Our Case Number: ACP-322958-25

Re: Athlone link road phase 2. Proposed link road, joining the Crescent Junction (R915) to Southern

Station Road Junction

RE: Athlone Link Road Phase 2

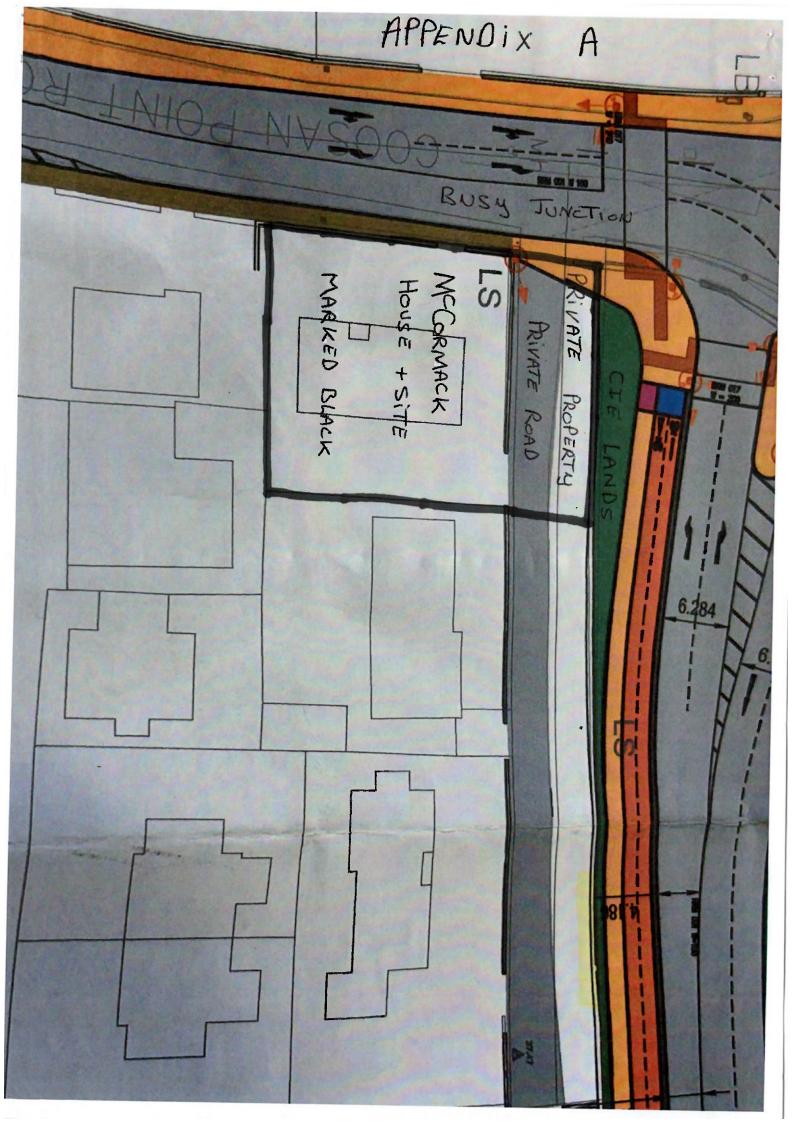
- Our house and site are on the entrance to the private laneway as outlined in black on the
 attached map (Appendix A). Please note corner shaded orange on entrance to private road
 on the attached map does not belong to Westmeath County Council and is part of my site
 boundary. This area includes several mature trees which borders the CIE Railway field with
 boundary wall.
